RESPONSE TO COMMENTS

December 02, 2019

Re: ATEC FDP (#1349317)/Pre-Application Meeting Held on February 21, 2019

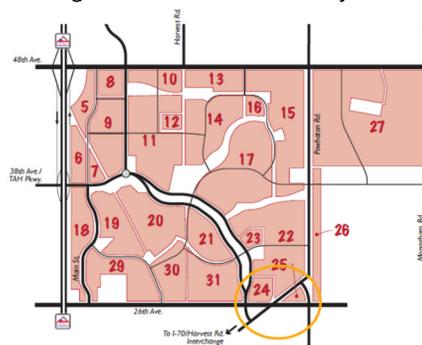
- Update to The Aurora Highlands Master Traffic Impact Study to remove the trips associated with these planning areas. It is anticipated that the total number of trips and analysis will not need to be redone, but allocating trips to background vs site generated.

- Series of intersections between Powhatan Rd, 26th Ave, connection to I-70/Harvest Rd interchange circled in orange below need to be analyzed to understand laneage, intersection configuration and queuing.

Response: The revised study shows the removal of all property east of Powhatan. Site-generated traffic was updated accordingly. Background traffic, being entirely based on NEATS Refresh, was not adjusted as the NEATS Refresh includes only minimal land use in the areas that were severed from the previous FDPs.

Response: The applicant proposes to have future studies will address this.
